**PLANNING COMMISSION AGENDA
CITY HALL AUDITORIUM, 250 NORTH 5TH STREET**

TUESDAY, JUNE 25, 2019 @ 6:30 PM

**PEPPER RIDGE SUBDIVISION VACATION OF RIGHT-OF-WAY AND PUBLIC
UTILITY EASEMENTS
FILE NO. VAC-2019-314 & VAC-2019-315**

Date: February 19, 2019 **Comment Round No.** 1 **Page No.** 1 of 15
Project Name: Pepper Ridge Subdivision **File No:** SUB-2019-3
Project Location: South end of W Indian Creek Drive

Sheet 2 of 2 PLAN GRAPHIC	
		Drexel, Barrell & Co. Engineers/Surveyors 3 SOUTH 7th STREET COLORADO SPRINGS, COLORADO 81501 719-260-0887 & BOULDER, COLORADO 303-442-4338	
Revised:	Date	Drawn By	Job No.
	04/12/19	TY/PCO	20005-02
	Scale	Checked By	Drawing No.
	1"=30'	PCO	Pepper Tree Filing 5

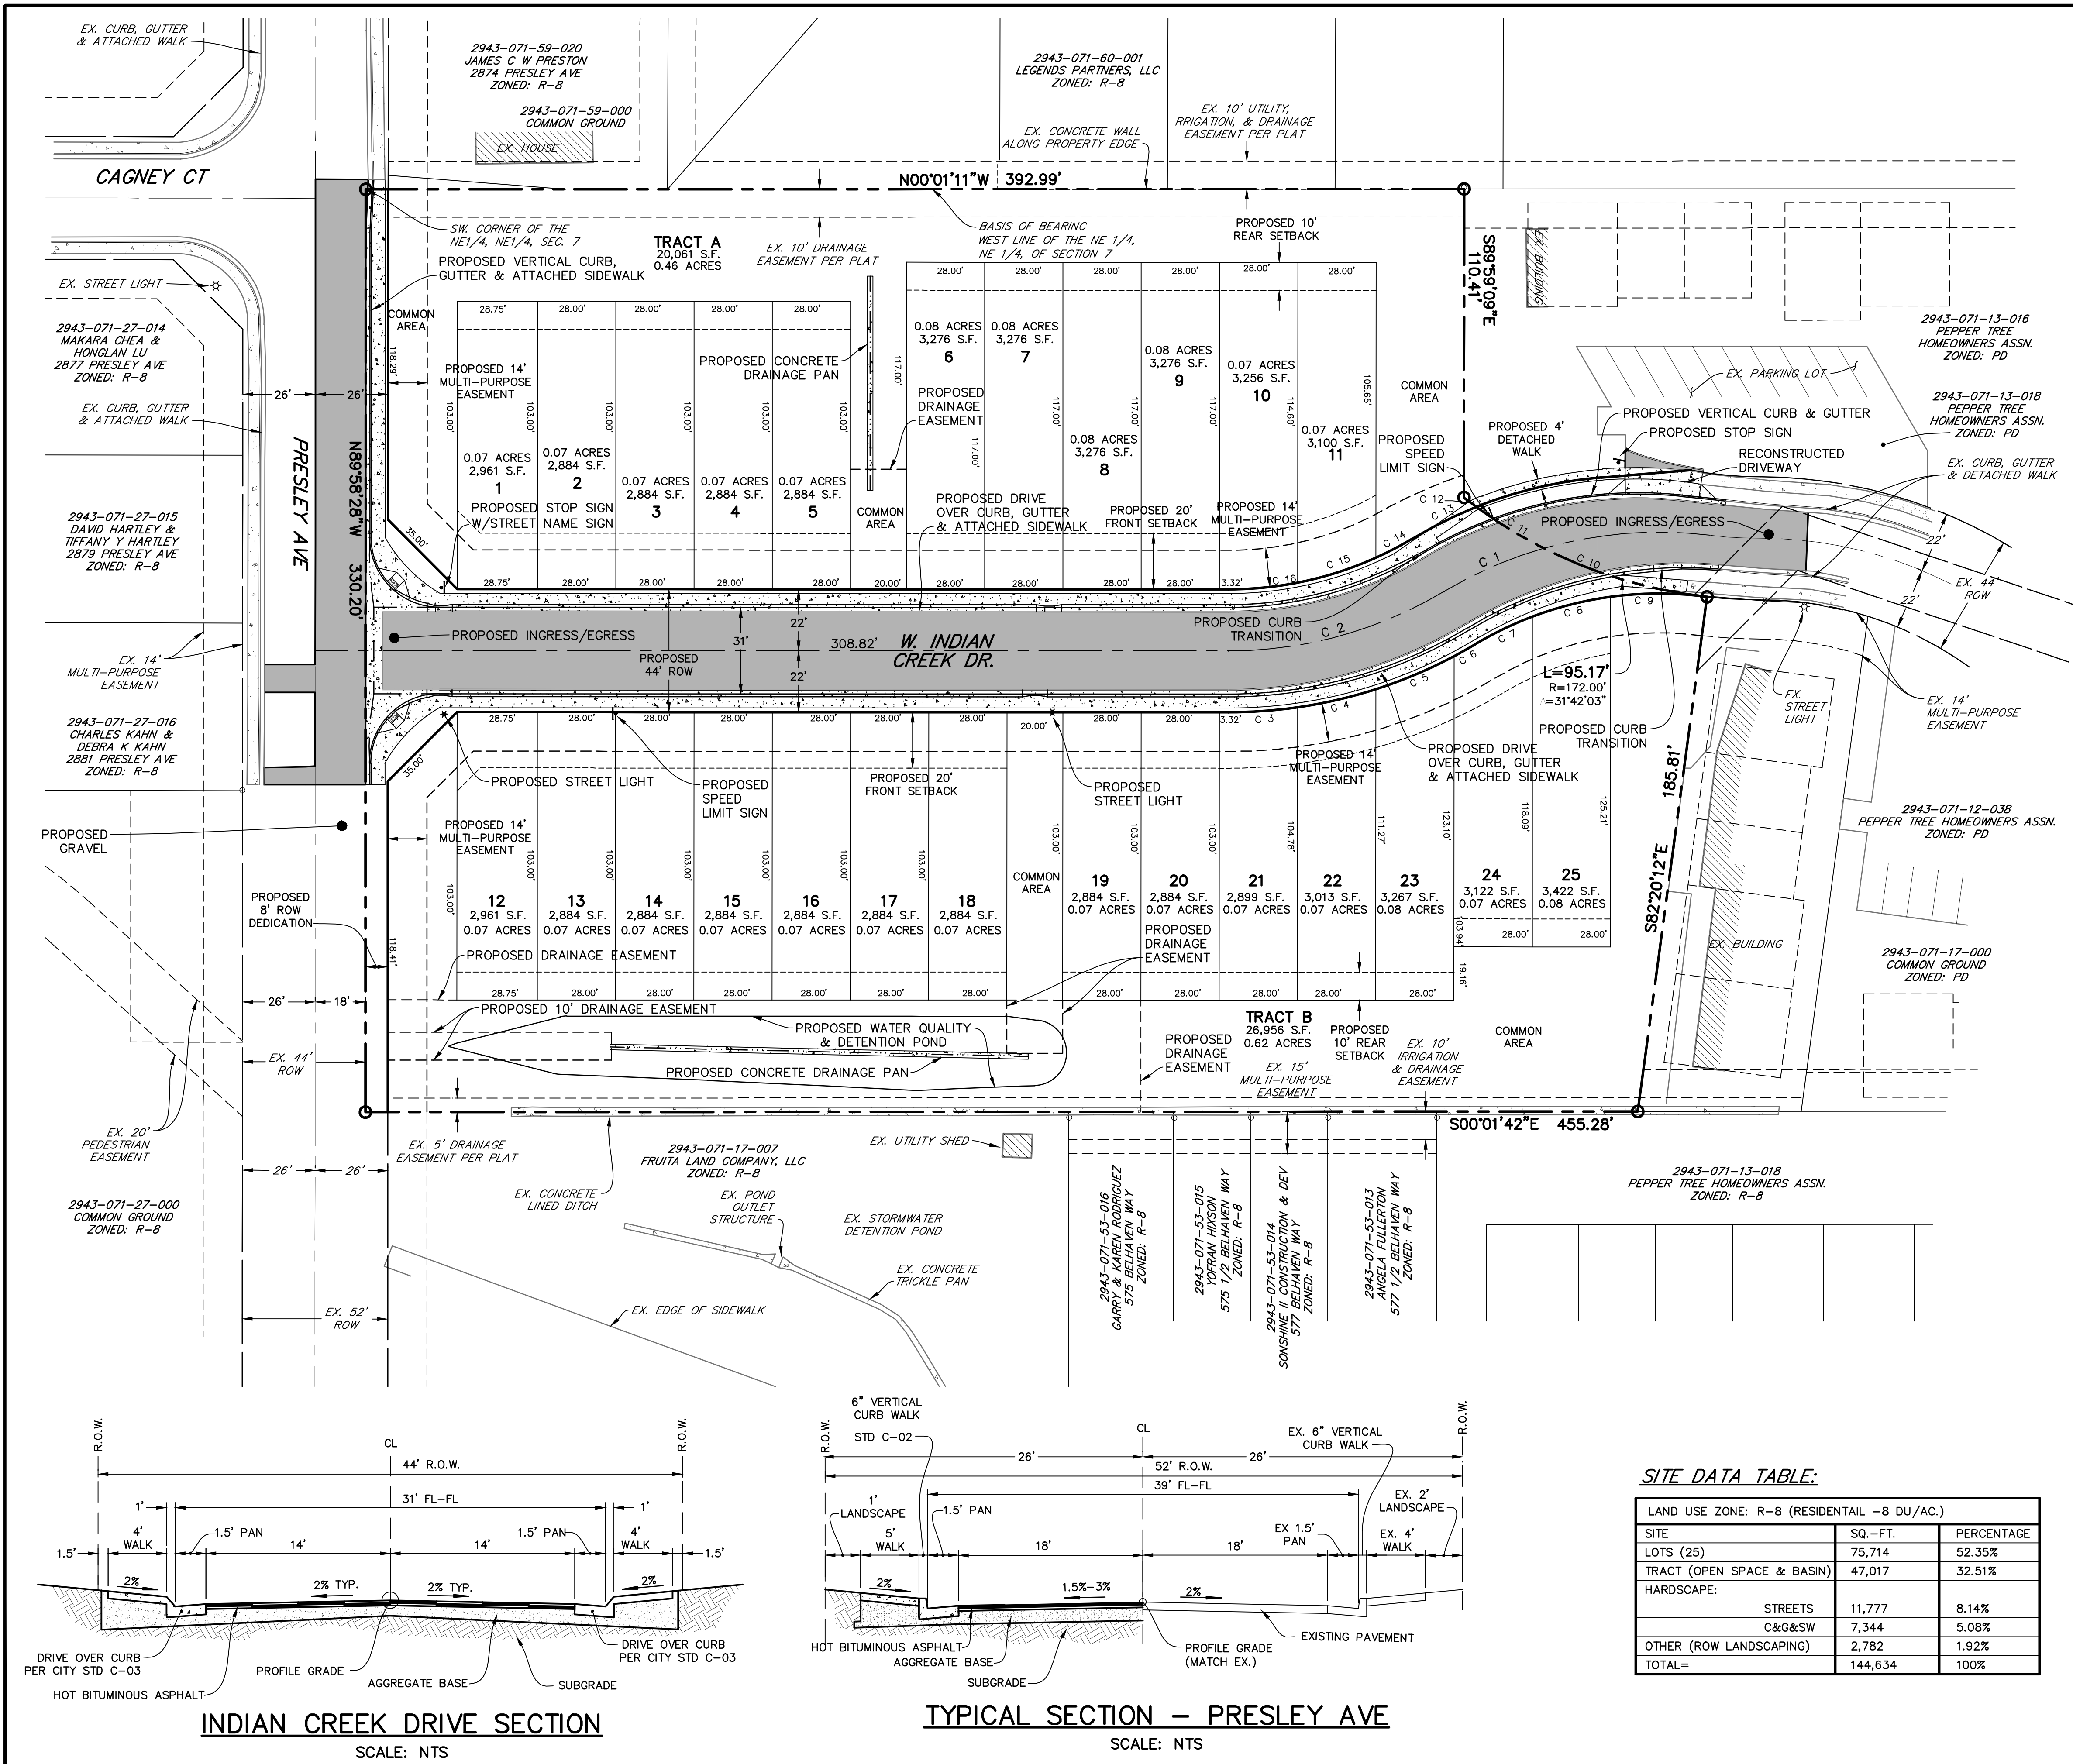
h. On Sheet 2, label the recording Reception Number for the existing 5' and 10' Drainage Easements located along the east and west property lines that are not being vacated.

- c. On Sheet 2, The arrows identifying the existing 22’ Utility and Access Easement as identified in Book 2793, Page 125 are not correct. Please adjust arrows to also include the land area encompassing the proposed 8’ right-of-way dedication.

Applicant's Response: Labels have been added as requested.

Document Reference: Subdivision Plat, Sheet 2.

1 Landscape Plan
SCALE: 1"=20'-0"

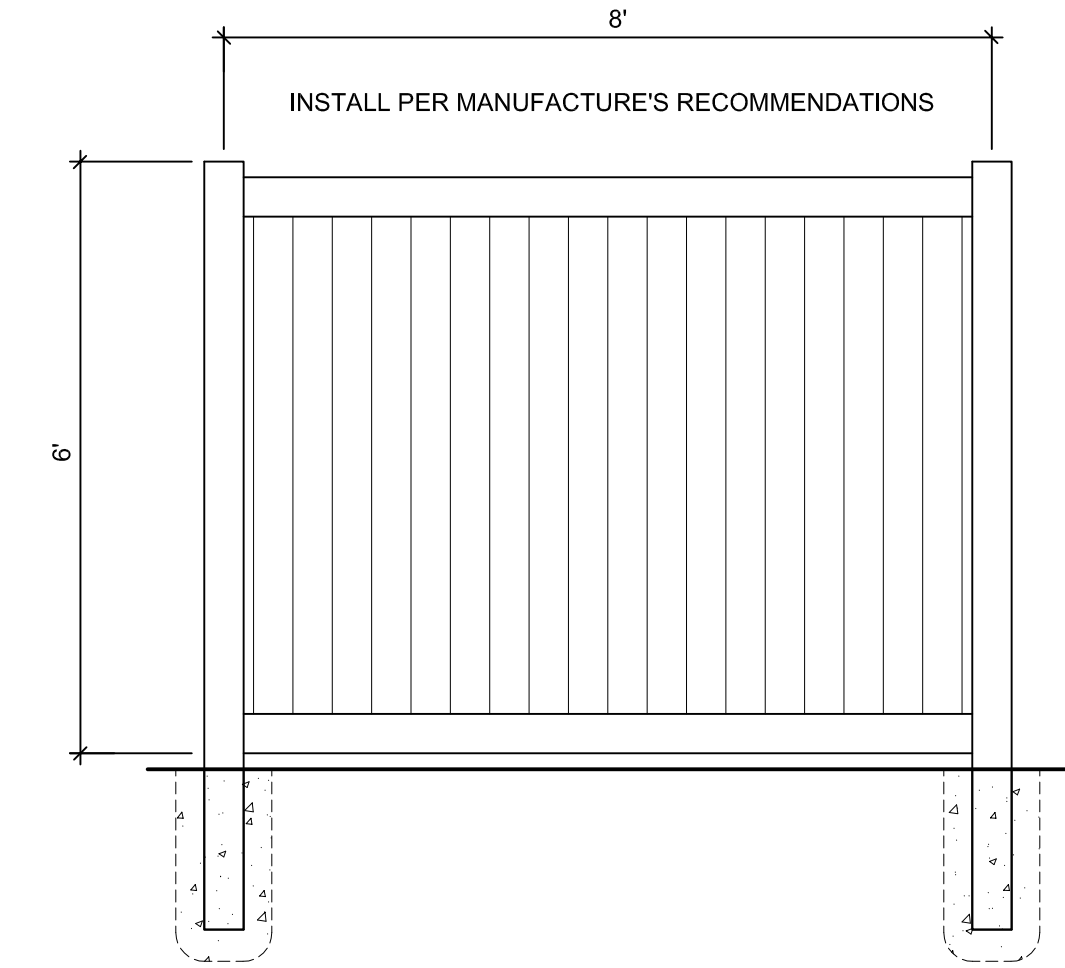
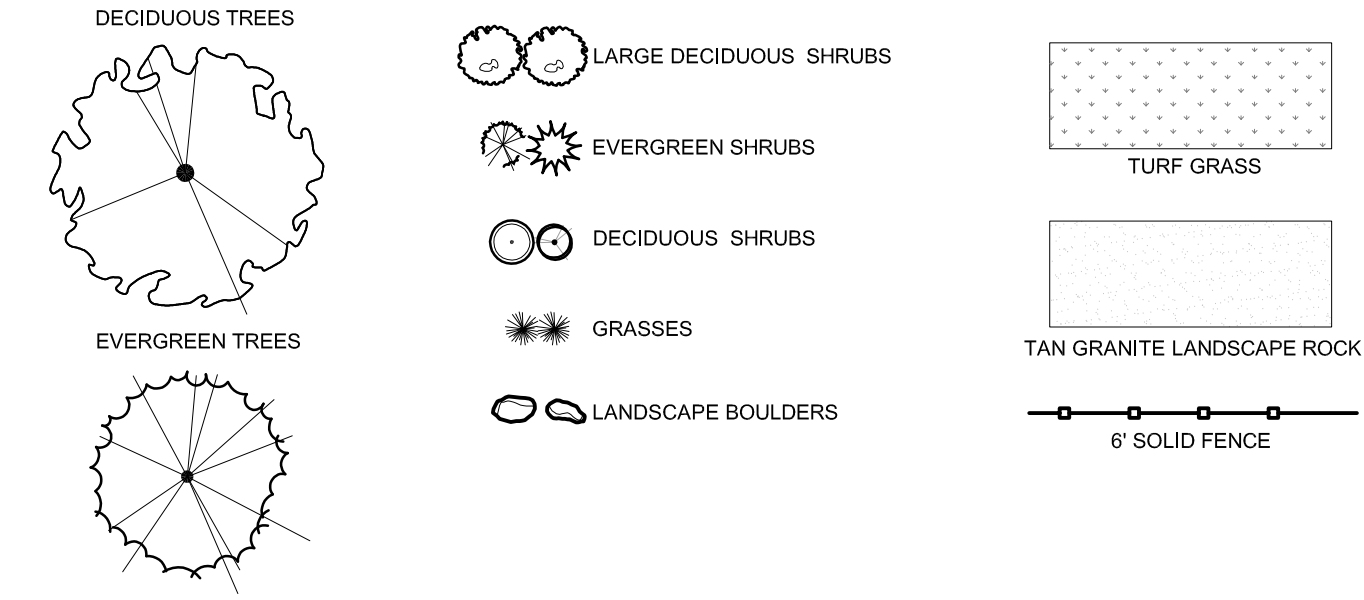
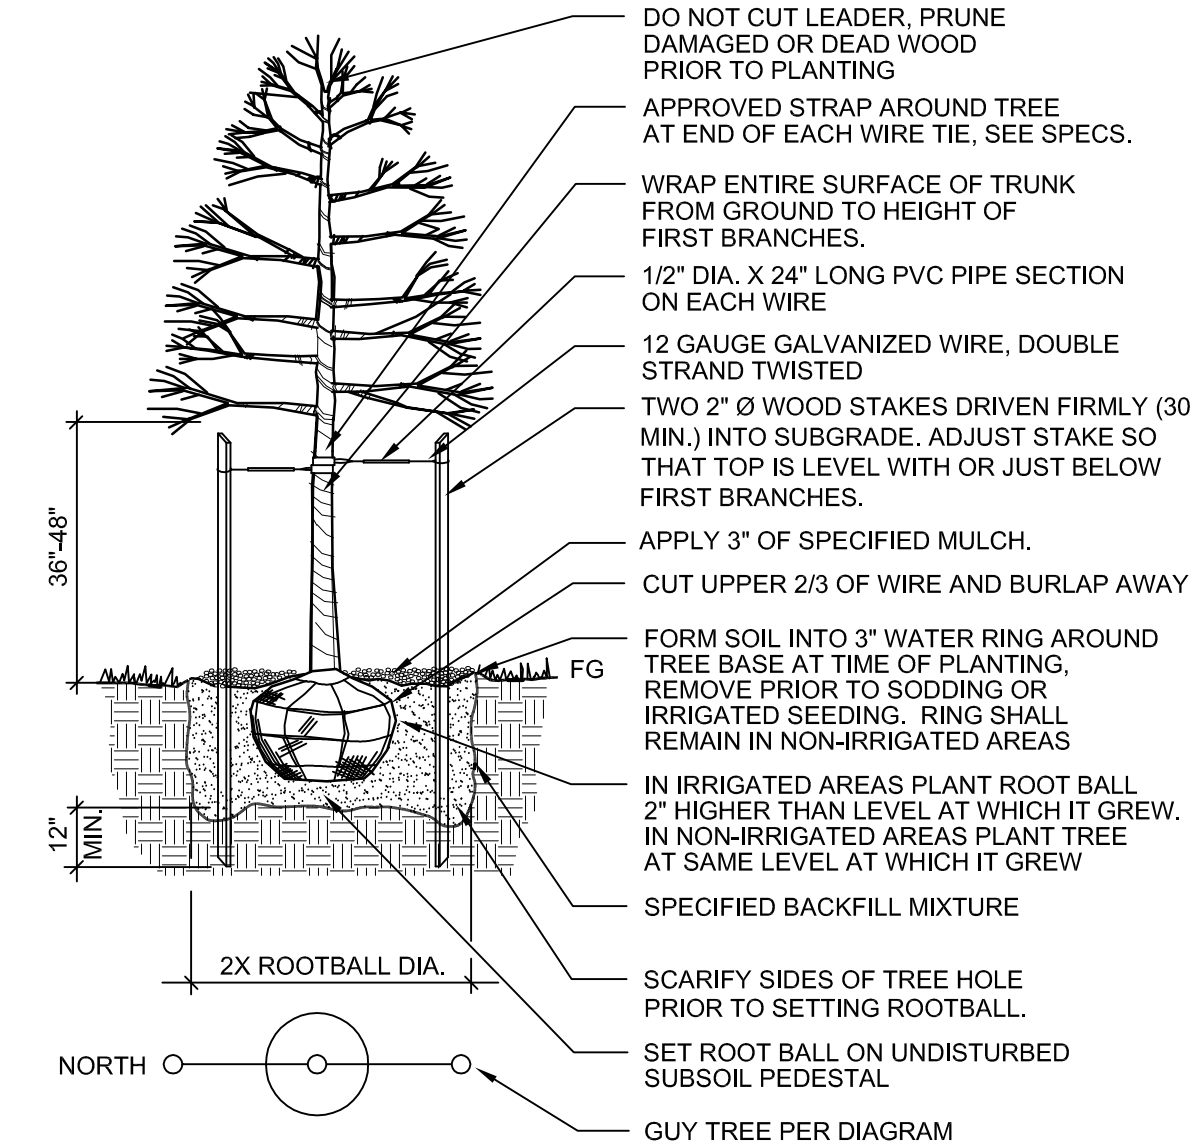
a. Label location of required 6' tall masonry wall or solid fence adjacent to Presley Avenue (Minor Collector). Proposed enclosure must be setback a minimum of 14' within the HOA tract (Section 21.06.040 (g) (1) & (5) of the Zoning and Development Code) and located outside of sight triangles. Include elevation drawing.

Applicant's Response: **6' solid Fence is shown**
